**Subject: Amended MHI's Response to US-APWR DCD RAI No. 491-3733 REVISION 0
(SRP 03.08.03)**

Amended Answers to QUESTION 03.08.03-17 of
RAI No.491-3733 REVISION 0

RAI NO.: NO. 491-3733 REVISION 0
SRP SECTION: 03.08.03 – Concrete and Steel Internal Structures of Steel or Concrete Containment
APPLICATION SECTION: 03.08.03
DATE OF RAI ISSUE: 11/23/2009

QUESTION NO. : 03.08.03-17

Figure 1 Free-body Diagram of the SG weight

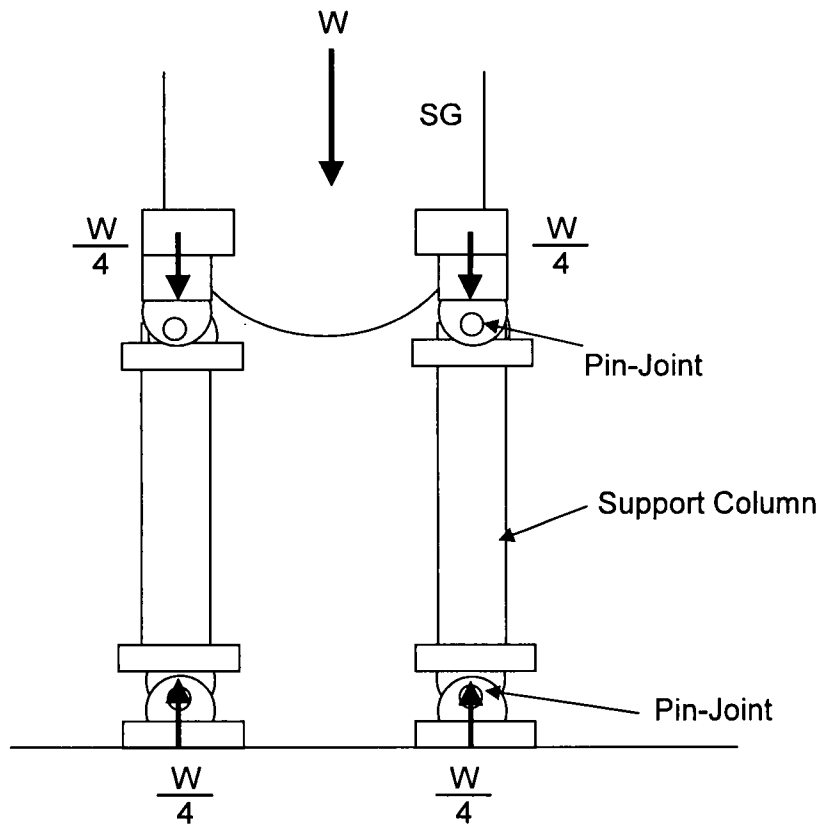
For Part (b) of their response, the information provided by MHI is acceptable in general. However, the figure provided in the answer causes another concern. It appears that the pins at the hinge joints would be subjected to a large force from the heavy steam generator (SG). The applicant is requested to provide a free-body diagram (sketch) of the SG showing the weight of SG and the reaction forces from the supports. Also, MHI is requested to provide the design calculations for the pins at the hinge joints and the details of the connection of the support columns to the supporting concrete.

A free-body diagram of the SG showing the weight of the SG and the reaction forces from the supports is shown in Figure 1. W indicates the weight of the SG that is supported in the vertical direction by the four support columns. The pin-jointed columns are designed to allow lateral movement, and therefore relieve horizontal reactions. Therefore, the acting force on each SG support column is nominally $W/4$ per support column. More information about the design calculations for the pins at the hinge joints are provided in Attachment A. The connection for the support columns to the supporting concrete is provided by the anchor bolts. Anchor bolts are buried in the concrete structure, and tightened with support column base plate by nuts.
